NOTICE OF MEETING

The City of Lake Elmo
Planning Commission will conduct a meeting on
Monday, May 23, 2011, at 7:00 p.m.

ITEM: Planned Unit Development Amendment – Bremer Bank Parking Lot Expansion

To: Kyle Klatt, Planning Director
Copies To: Jack Griffin, City Engineer
From: Ryan Stempski, P.E.
Date: May 16, 2011

UTILITY PLAN

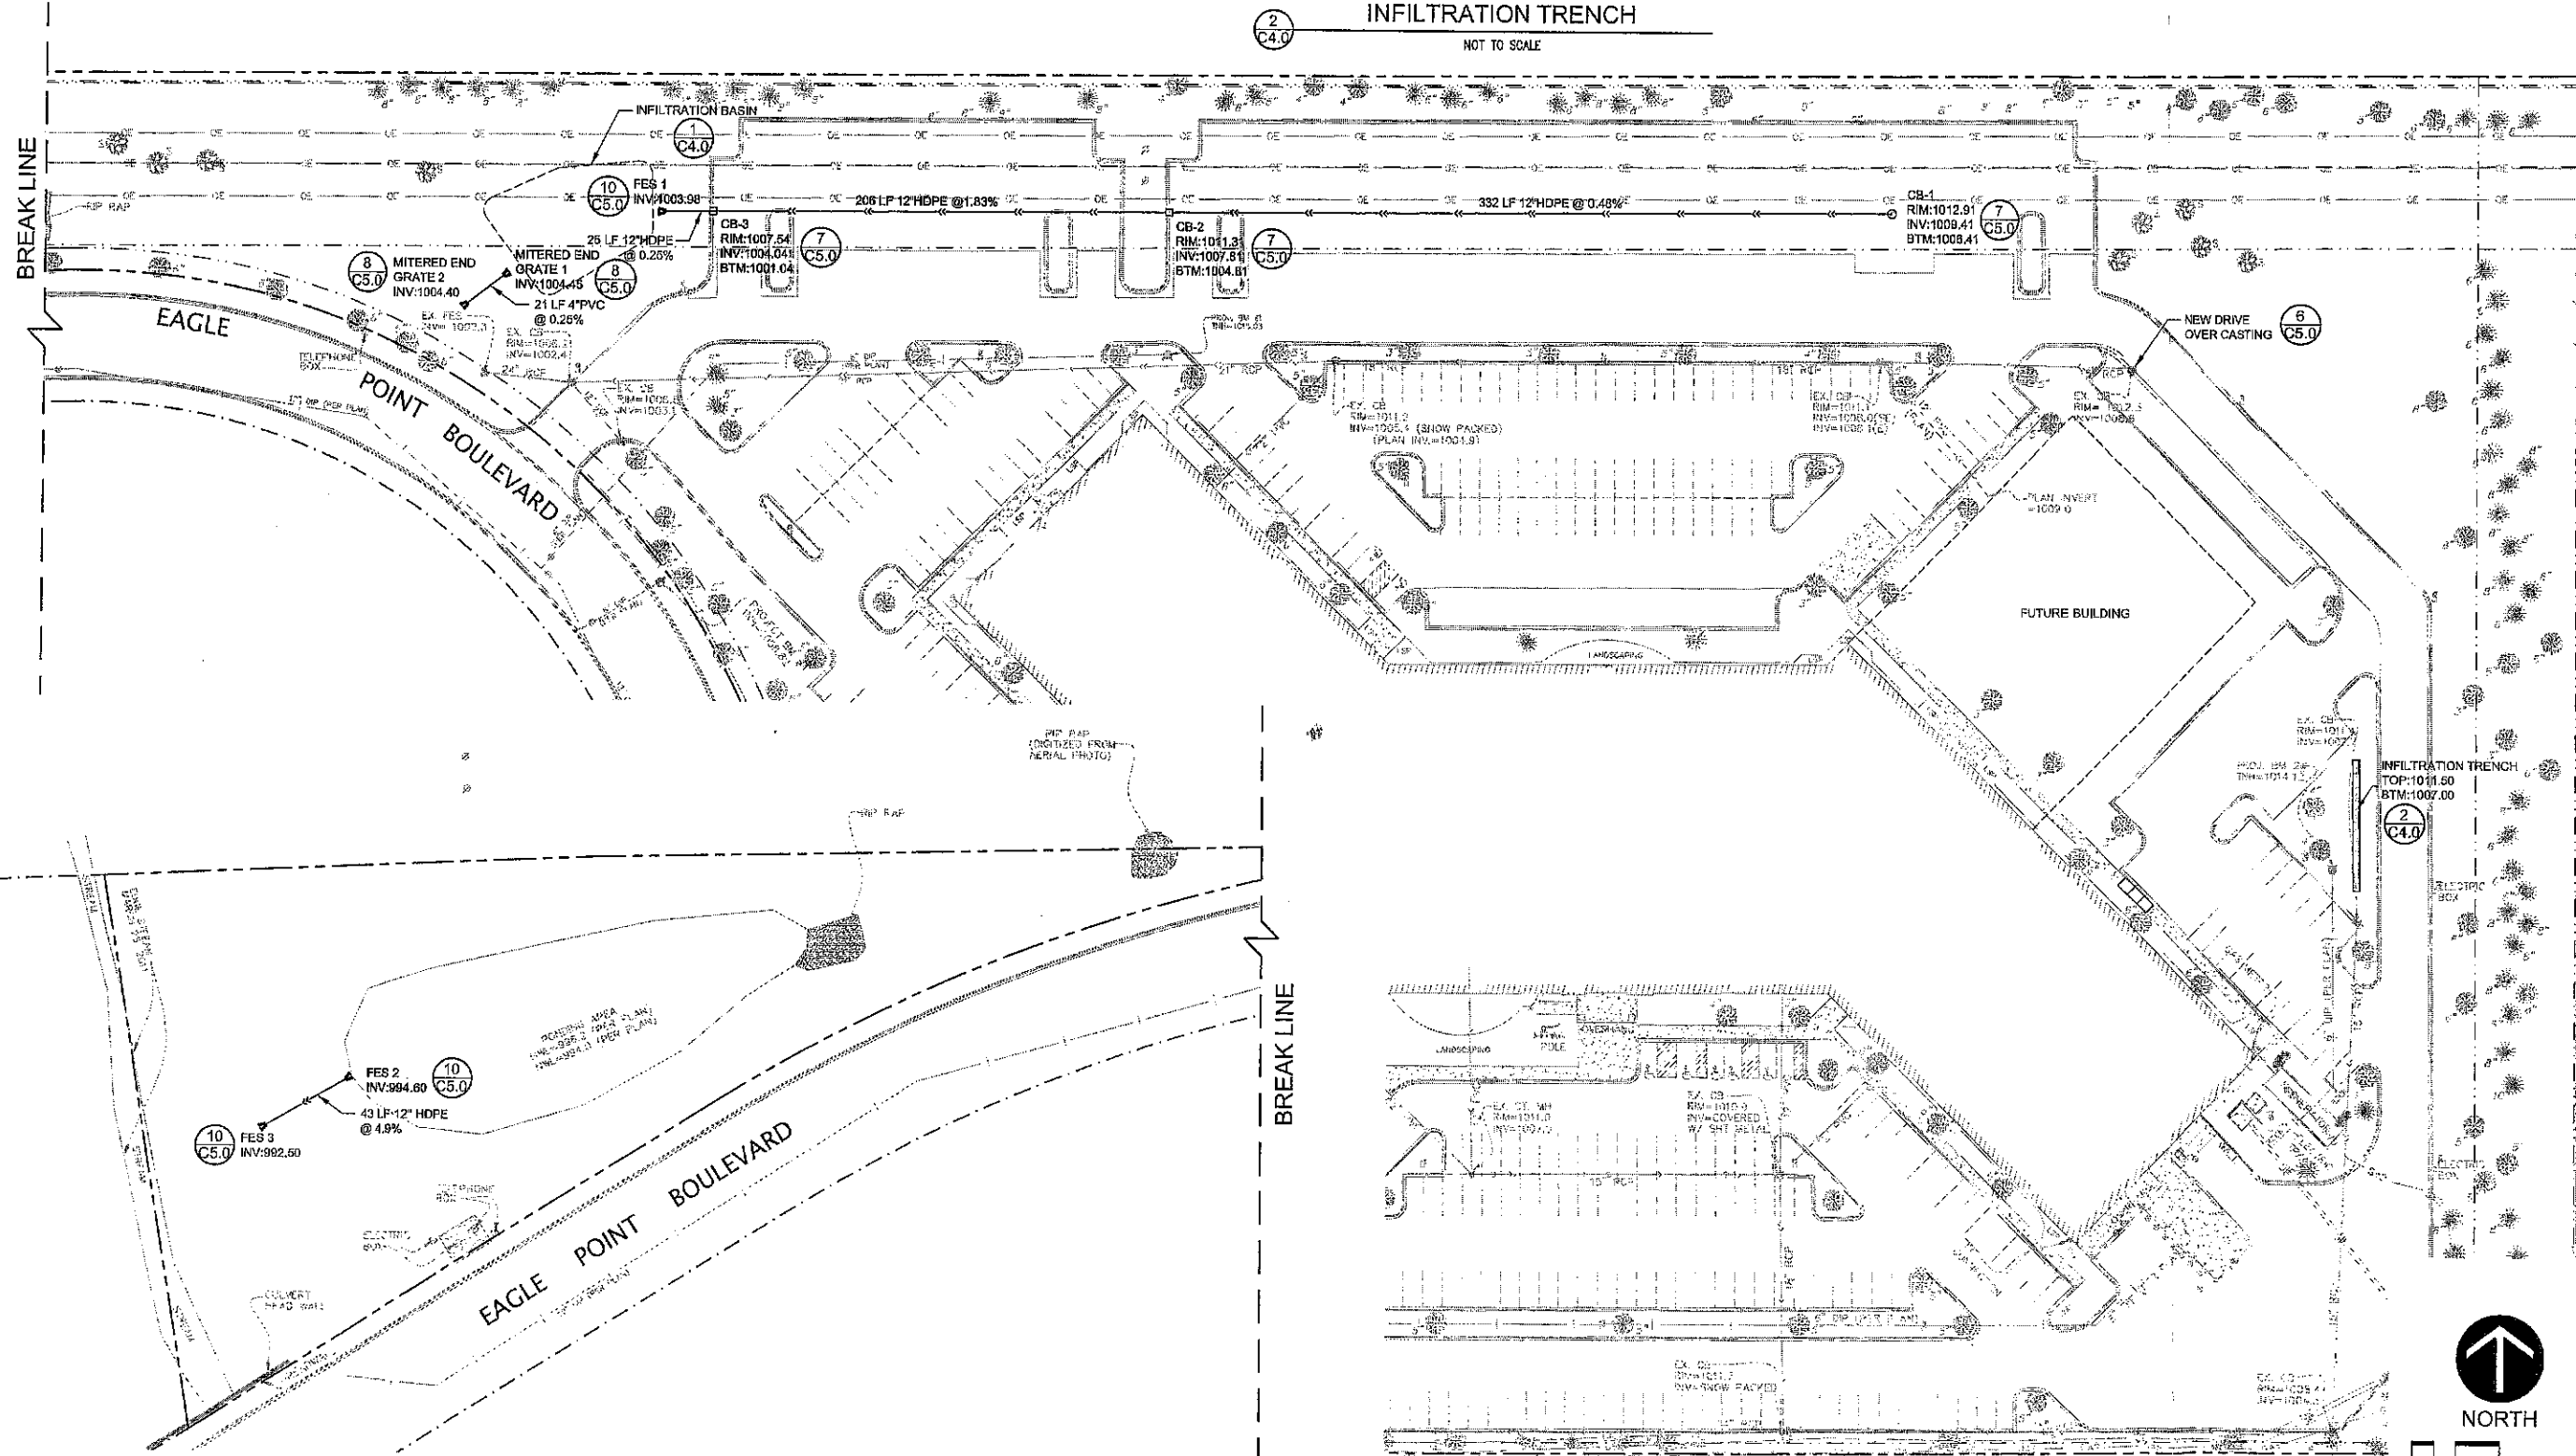
6. Outlet detail for Infiltration Trench must be provided.
7. Easements must be provided up to the 100-Year HWL for all Storm Water Facilities.
8. A Maintenance Agreement must be provided for all Storm Water Facilities.
9. The location and typical section for a rock construction entrance must be provided on the Plan.
10. Any material to be removed off-site should be identified on the plan with a hauling route identified.
